**ITEM 7. DEVELOPMENT APPLICATION: 106 - 116 EPSOM ROAD
ZETLAND****FILE NO: D/2011/1760****DEVELOPMENT APPLICATION NO: D/2011/1760****SUMMARY****Date of Submission:** 2 November 2011**Applicant:** Mecone Pty Ltd**Architect:** Architects + Partners**Developer:** Lincon Development Pty Ltd**Key Points**

Stage One development application for six building envelopes. The proposed gross floor area is 53,900m², which includes 1000m² of commercial floor space, up to 561 residential dwellings and parking for up to 515 cars within three separate basement carparks.

Figures 7: Proposed site layout

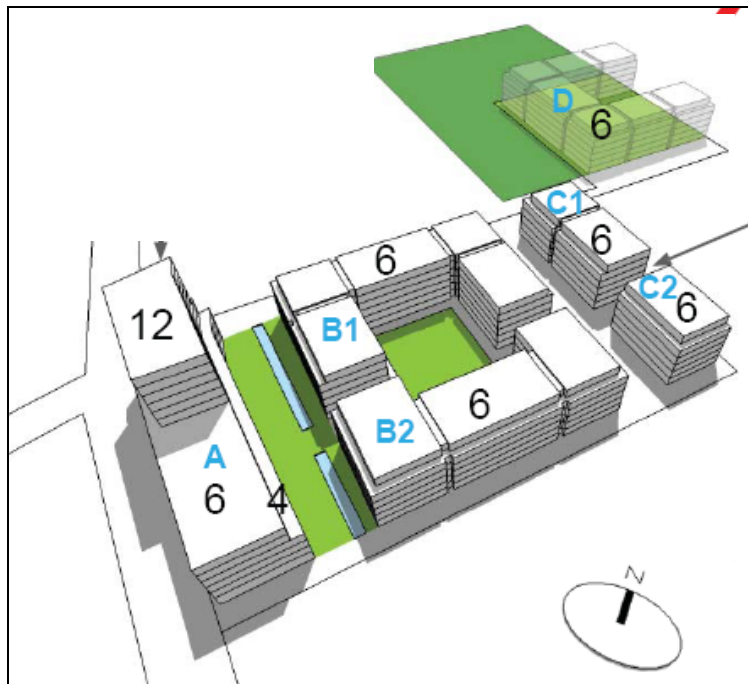
24. The proposed Stage One application for a 53,900m² mixed commercial and residential development. The development comprises 1000m² of commercial/retail floor space fronting Epsom Road and 52,900m² of residential floor space. Up to 561 residential units are proposed as well as up to 515 car spaces within three separate basement car parks.
25. The proposed site layout consists of six building blocks, as shown in Figure 7. Block A will have a maximum height of 12 storeys (41.94 metres to the top of the building), while Blocks B1, B2, C1, C2 and D will each be six storeys.

26. The site has been configured with the tallest structure along Epsom Road and the lower structures behind. Open space is provided in two sections on the front portion of the site, including within the area surrounded by Blocks B1 and B2. The rear portion of the site contains a U-shaped building built up to the northern boundary, with public open space provided along southern edge (see Figures 7 and 6).

27. The two portions of land are connected via a north-south accessway that varies in width between 4.9 metres and 6 metres.
28. The proposal includes a range of other works including new roads, through site links, canal works, stormwater and flood mitigation infrastructure and general landscaping, and the provision of 5375m² of public open space (which contributes approximately 3000m² to the development's deep soil planting).

Figure 11: Epsom Park street layout (Draft Sydney LEP 2010)

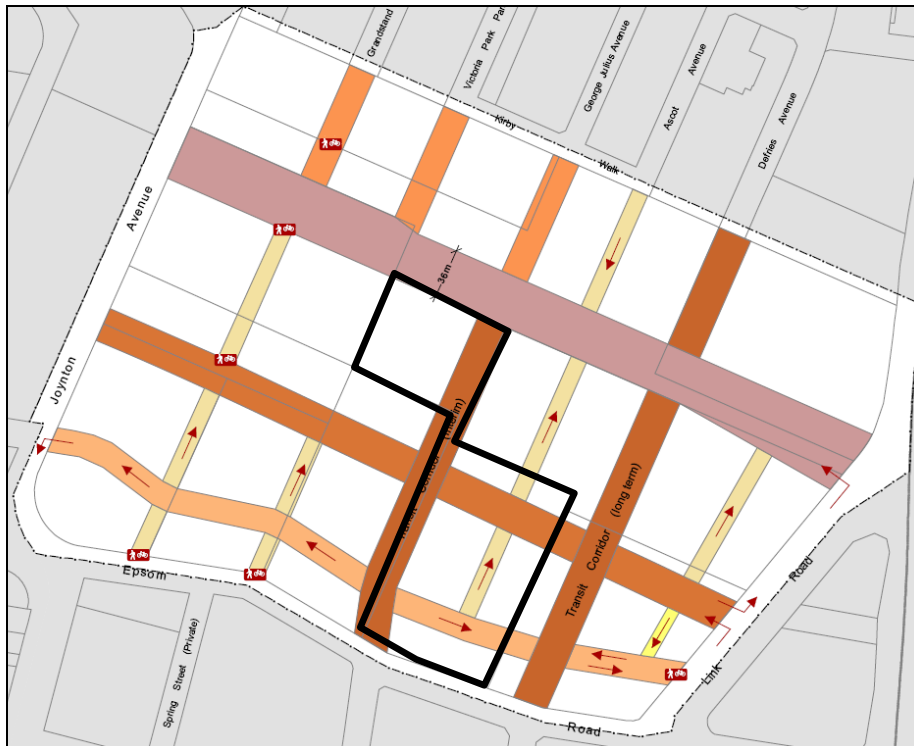
64. The proposed development does not comply with the future road network identified in the Draft DCP for the following reasons:
- Blocks C1 and C2 are encroaching onto the two future east-west streets running through the front (southern) portion of the site. The dedication of land to create these streets is essential to the appropriate future functioning of the street network for the whole precinct.

- A pedestrian through site link is proposed in the location of a future 12 metre wide north-south road running through the front portion of the site.

- The north-south driveway between the two portions of land is proposed to be between 4.9 and 6 metres wide. The Draft DCP shows this road as being between 23 and 25 metres wide.

65. In summary, the widths and layouts of the roads are generally not in accordance with the South Sydney DCP or Draft DCP. Therefore, dedication of land to the City for the purpose of public roads in the locations proposed is not supported.

Figure 12: Building heights provided in the Draft Sydney LEP 2011

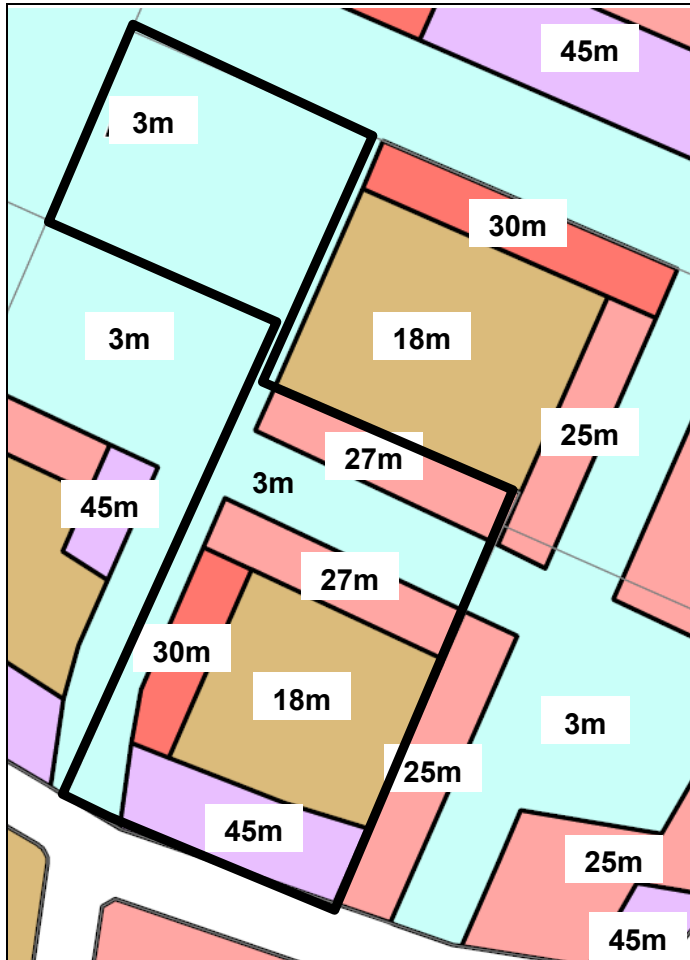
70. The proposal seeks to benefit from the draft controls on the front portion of the site, where a maximum building height of 41.94 metres is proposed for Building A (see Figure 13). Under the Draft LEP building height is measured to the highest point of the building.

Figure 13: Building heights provided in the Draft Sydney LEP 2011

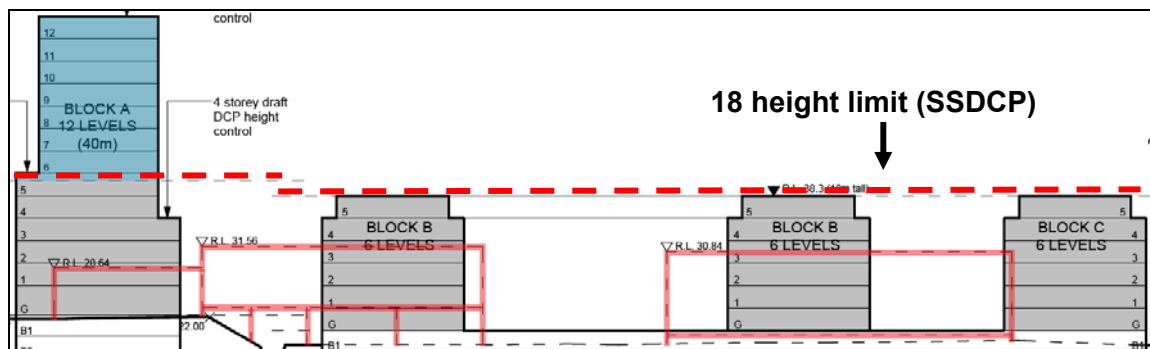
71. On the rear portion of the site the draft controls have been disregarded and the existing South Sydney height control of 18 metres has been applied. Building D has a height on 17.7 metres, which is measured to the ceiling of the uppermost floor.

72. The draft height control needs to be considered in conjunction with the other draft planning controls applicable to the site. This includes a reduction in FSR and the appropriate dedication of land for roads and public open space.
73. The applicant has selected the optimal height controls from the current and draft controls and applied these across the site to maximise the development. This approach is not supported as it creates significant inconsistencies with the future layout and form for the Epsom Park precinct. Accordingly, the proposed height (particularly that of Building D) is not supported.
